Intersection ID: 50563	Main Street: MORGAN_CREEK_DR	Cross Street: SMOKE_MONT_DR	Location:	NW
ADA ID: 420993BAA74F	Ramp Type: BlendTrans1	Initial Pass/Fail: Pass	Overall Compliance: No	Severity Score: 0

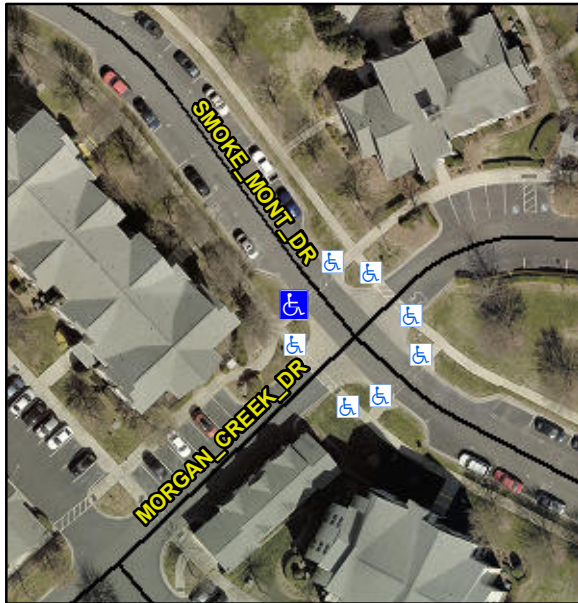
Not Found, R304.2.2-Perp, R304.3.2-Para, R305.2

Yes	Ramp inside XWalk1?	Yes	N/A	Ramp inside XWalk2?	N/A
	Road Slope (%)	0.6		Clear Space?	Yes
	Road X Slope (%)	1.3	N/A	Clear Space to XWalk (in)	N/A
Yes	Any Obstructions?	No	Yes	Storm Grate/Utility Hazard?	No
	Obstruction Type			Storm Grate/Utility Type	
		N/A			N/A
			Yes	Surface Condition? (G/P)	Good
			No	Curb Slope (%)	10.2

Remove & Replace Curb Ramp With Two New Directional Ramps or Equivalent.
